Q664 UPS10216-2BNAS1

TECHNICAL BULLETIN

Update Prior to Sale: Incorrect Bracket Fitted To 3.0V6 Supercharged Petrol

MODEL:	MODEL YEAR:	VIN:	ASSEMBLY PLANT:	APPLICABILITY:
Range Rover Sport (LW)	2017	667482-671021	Solihull	V6 S/C 3.0L Petrol

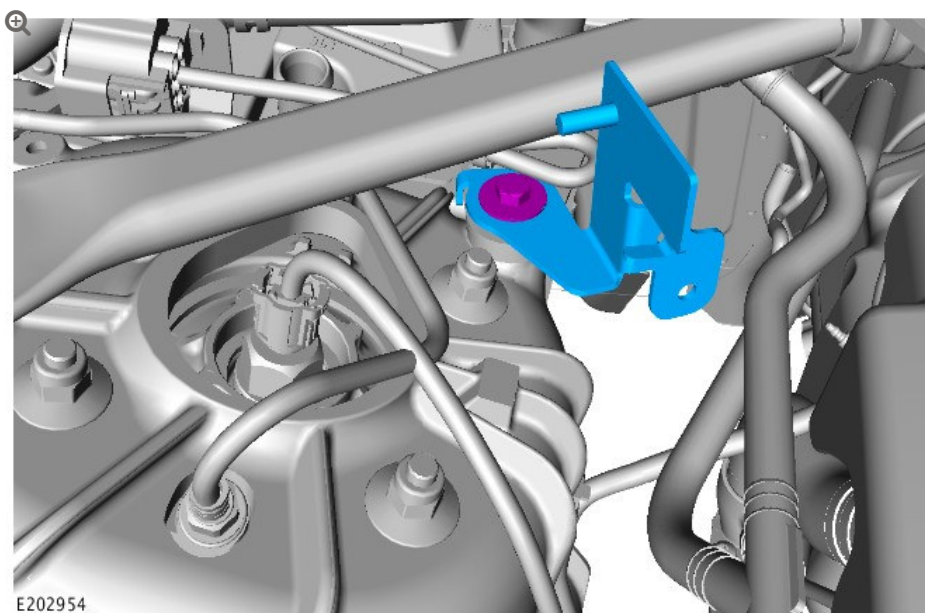
Remove and discard the unused bracket near the front right suspension top mount.

Retain the bolt.

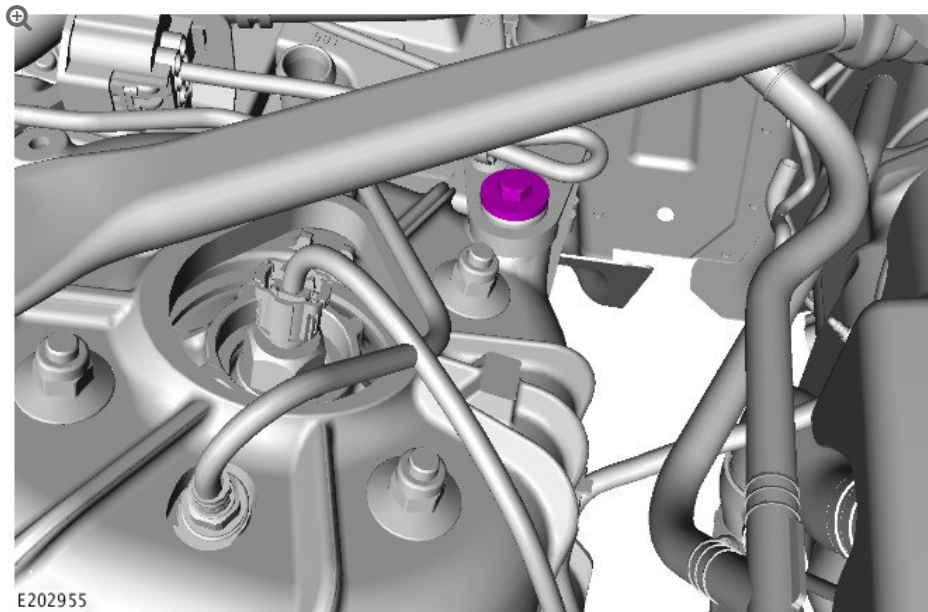
Make sure the bolt secures the auxiliary pump eyelet.

Install the bolt back in the same location.

- Torque: **9 Nm**.
